# STHDI Pre-Bid Site Visit Field Questions – 12/23/2024

## Final

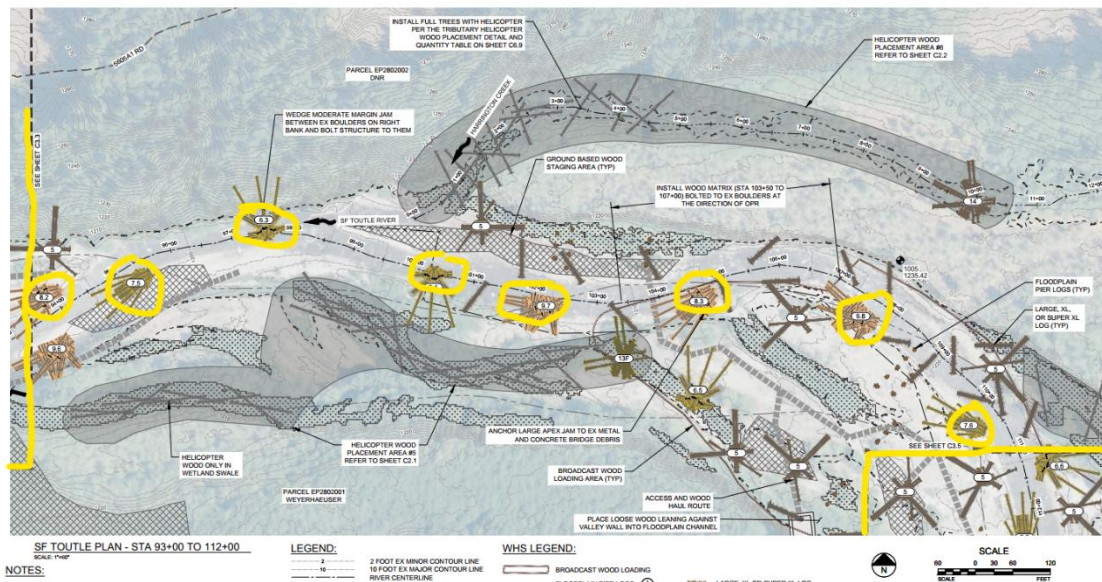
- Question: Regarding 2-04.3(1) and (2) – Will the slash be piled in the harvest units or does the Contractor need to gather it for transport?

- Answer: The logging contractor will pile the slash into piles appropriate for each staging area or placement area. Each pile will be strategically placed to minimize secondary transport For example, looking at Sheet 7 (Staging and Helicopter Plan for Reach A), the logging contractor will prepare four piles:

- **Helicopter Staging Area 1:** 120 CY – this pile will include bundles of slash prepared by the logging contractor ready to fly with the helicopter. The piles will be up to 9000 pounds each. We expect the slash to weigh about 1 ton per 8 CY; so, 120 CY would weigh about 30,000 pounds and would be split this into 4 bundles to keep each under 9,000 pounds. Bundles will be built using small logs as cribbing.

- **Helicopter Staging Area 2:** 100 CY would weight about 25,000 pounds and would be split into 3 bundles. These bundles along with bundles for Helicopter Staging Area 1 will be staged in harvest units 2 or 3 for the shortest haul distance via helicopter.

- **Trucked Staging Area 1:** 410 CY of slash – this will weigh about 102,500 pounds and will be staged adjacent to access roads so that the instream contractor can load it and transport it.

- **Helicopter Wood Placement Area 1:** 22 slash bundles will be prepared by the logging contractor for placement in Bear Creek.
